UNITED STATES PATENT AND TRADEMARK OFFICE

APPLICATION NO.	FILING DATE	FIRST NAMED INVENTOR	ATTORNEY DOCKET NO.	CONFIRMATION NO.
10/823,242	04/13/2004	Patrick J. Garavan	H0682.70006 US00	4070

Office Action Summary

DETAILED ACTION

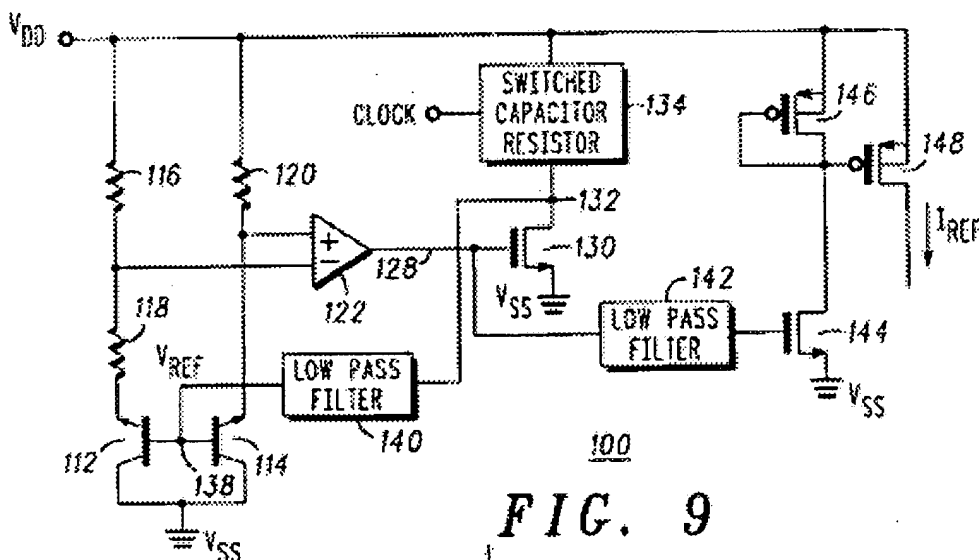
2. Figures 1 and 2 should be designated by a legend such as --Prior Art-- because only that which is old is illustrated. See MPEP § 608.02(g). Corrected drawings in compliance with 37 CFR 1.121(d) are required in reply to the Office action to avoid abandonment of the application. The replacement sheet(s) should be labeled "Replacement Sheet" in the page header (as per 37 CFR 1.84(c)) so as not to obstruct any portion of the drawing figures. If the examiner does not accept the changes, the applicant will be notified and informed of any required corrective action in the next Office action. The objection to the drawings will not be held in abeyance.
